Re: Route 66 Plaza
8521 Central Ave NE
Request for Certificate of Occupancy
Transportation Development Final Inspection
Engineer's/Architect's Stamp dated 5-17-16 (K19D043)
Certification dated 3-20-19

ROUTE 66 PLAZA - LIVE/WORK DEVELOPMENT
SITE PLAN & PROJECT INFORMATION
8521 CENTRAL AVE. ALBUQUERQUE, NM
PROJECT #1611

TRAFFIC CERTIFICATION

SITE PLAN
SCALE: 1"=10'-0"

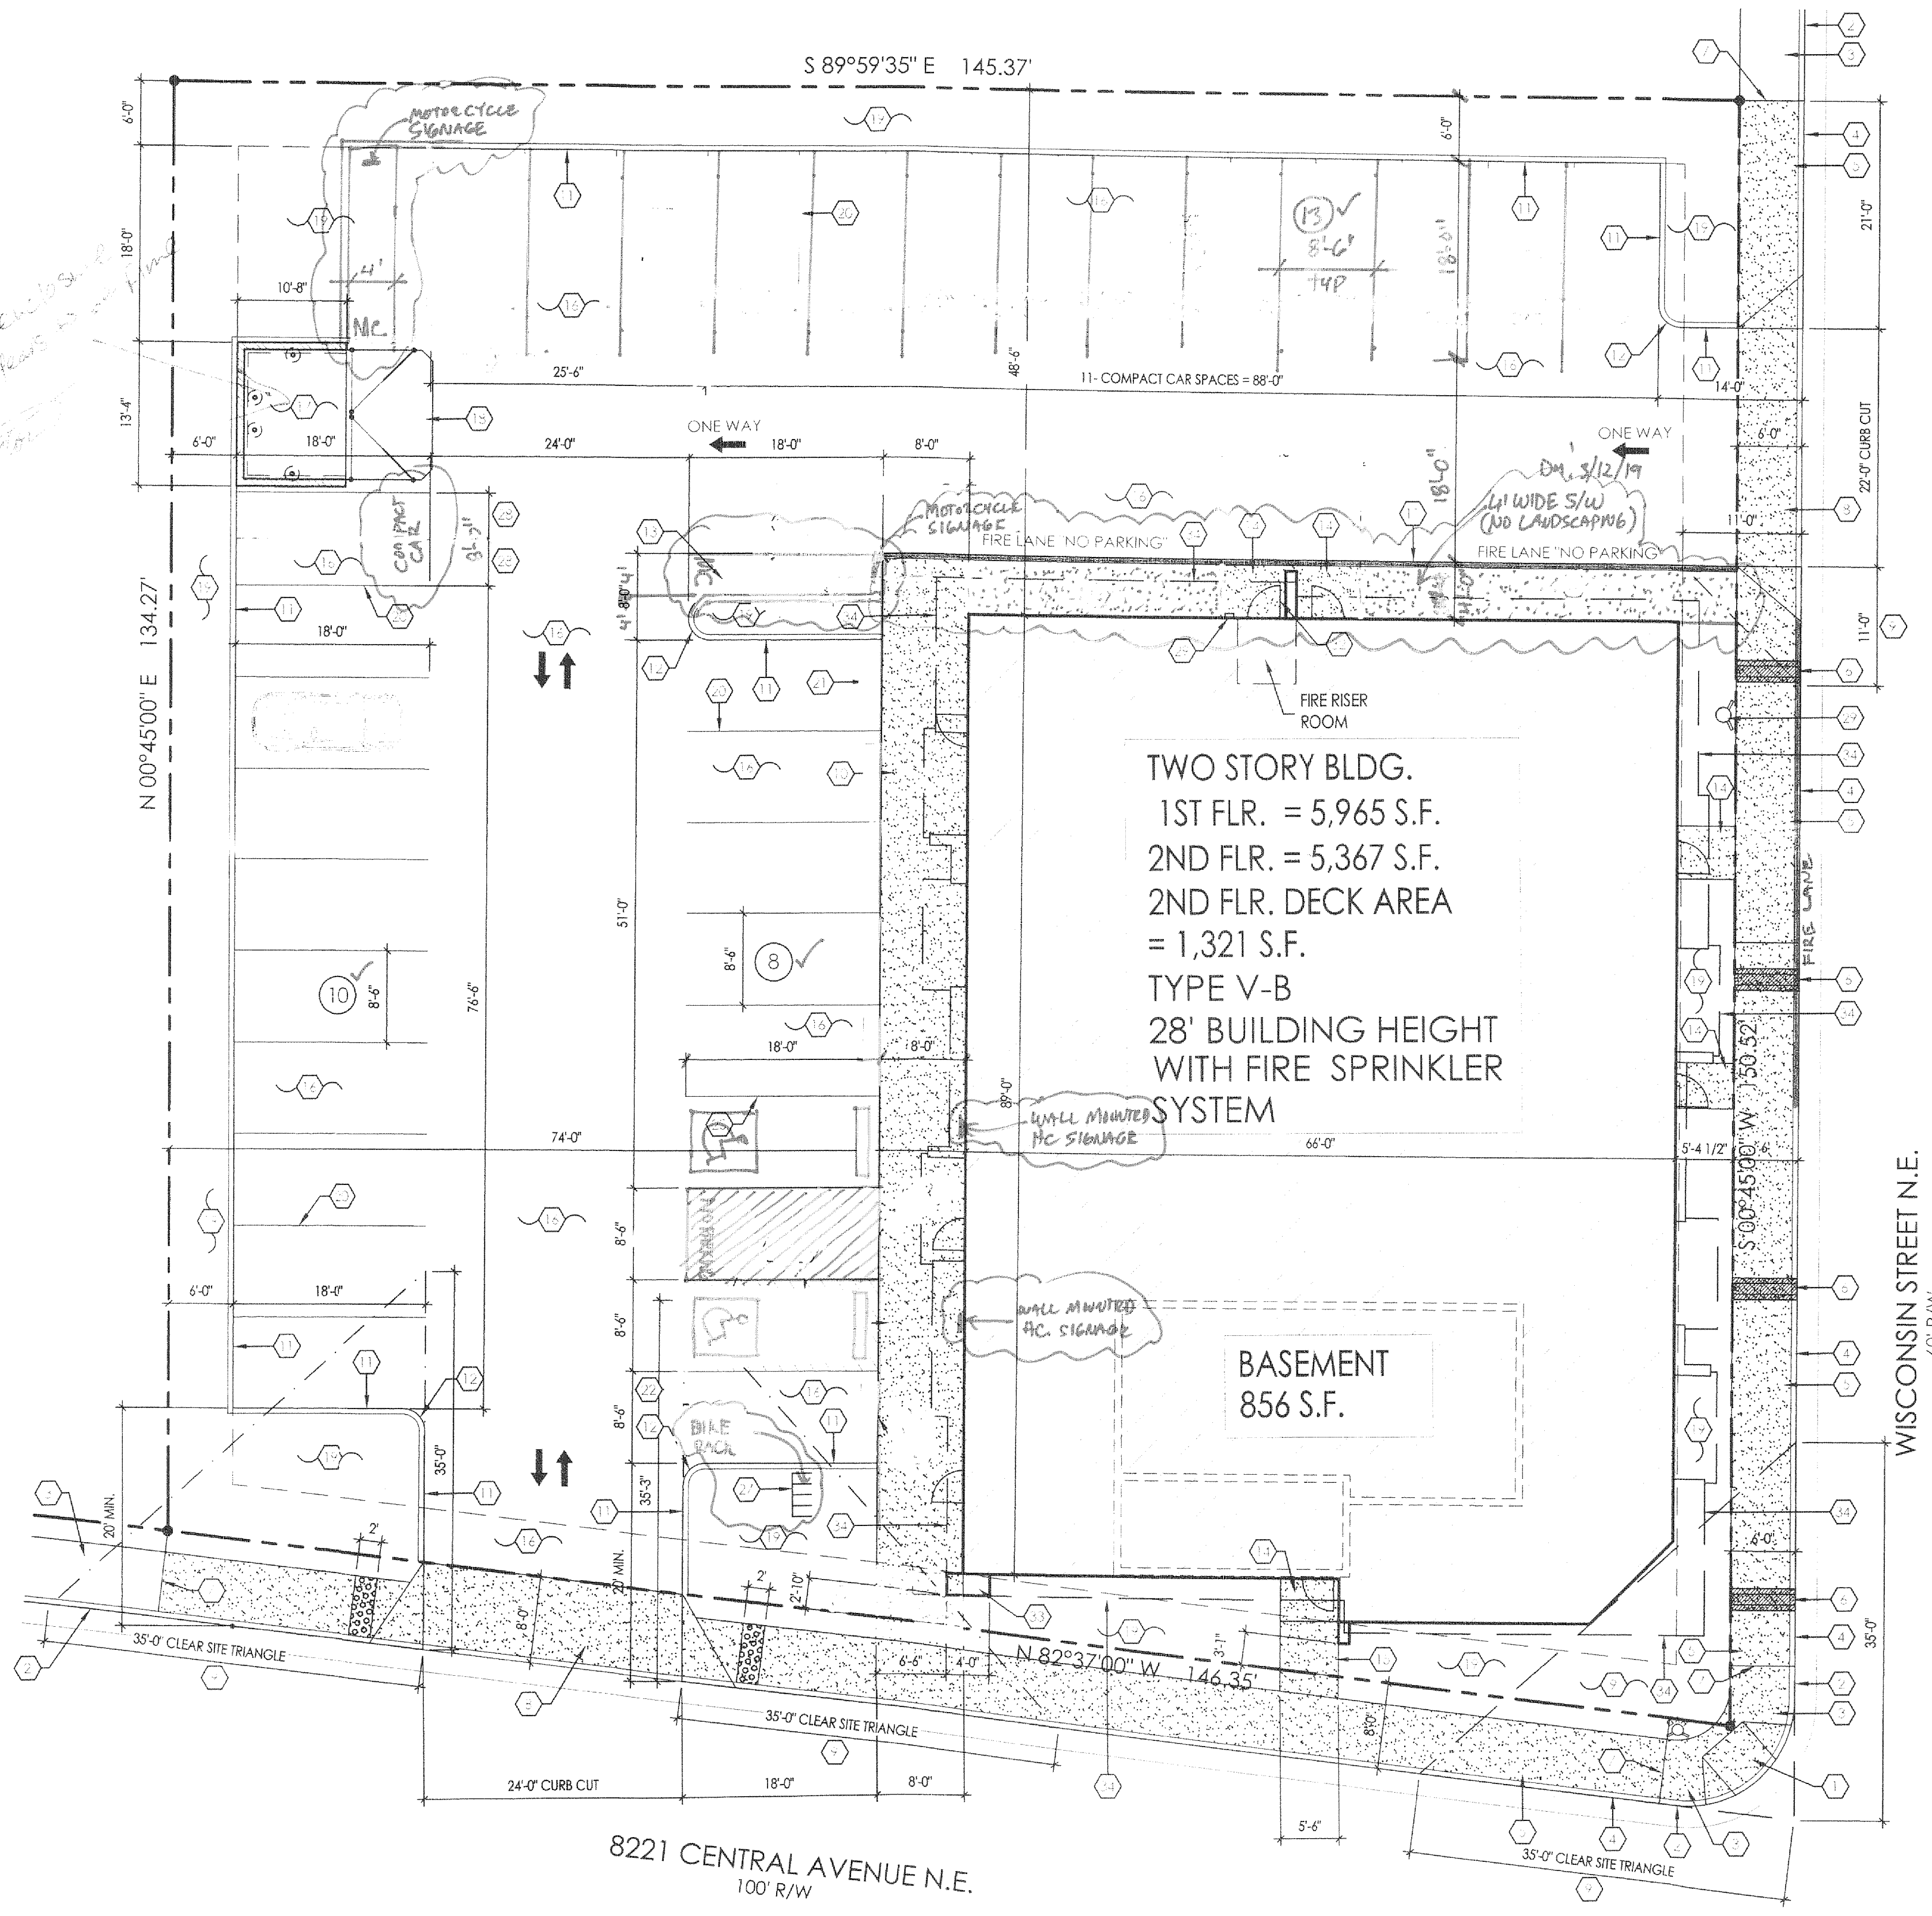
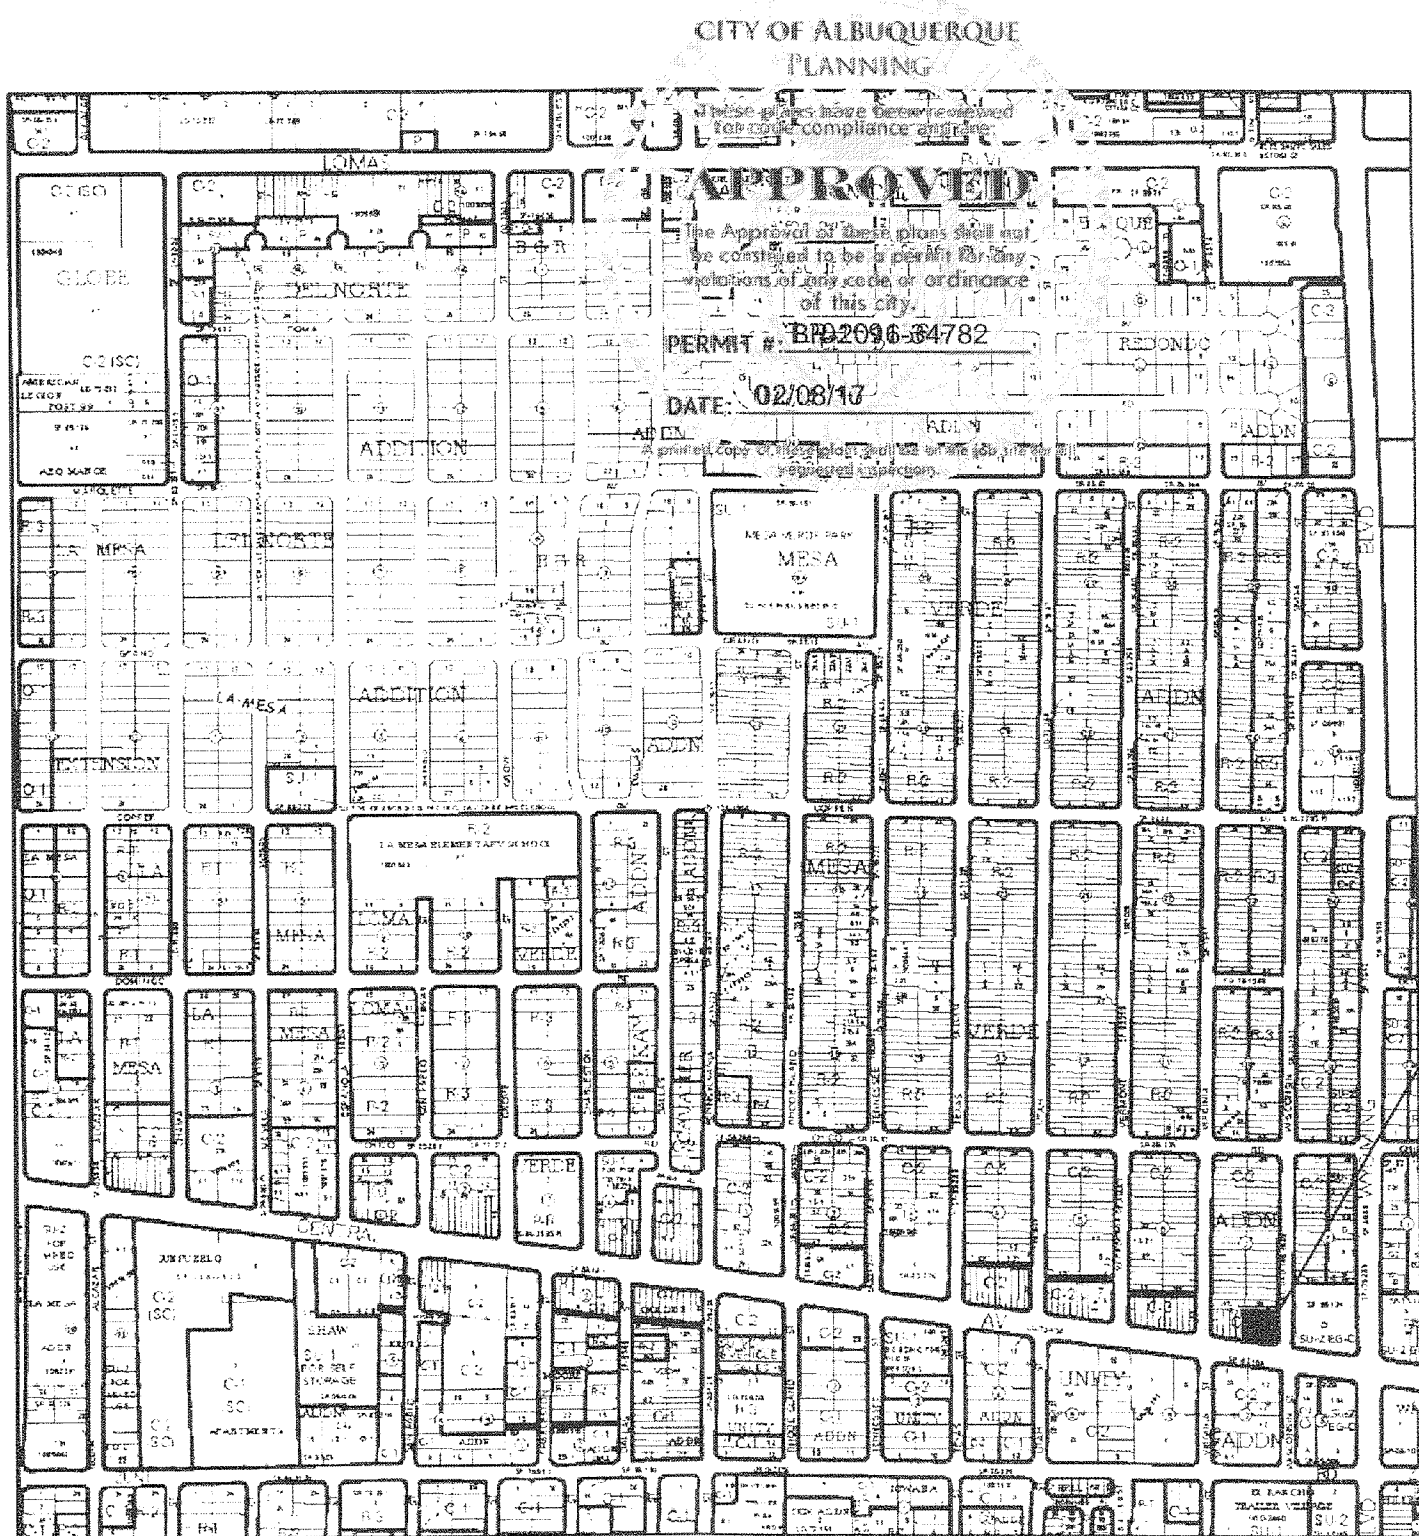
Remove enclosure
Location appears to be wrong
Solid line to be removed
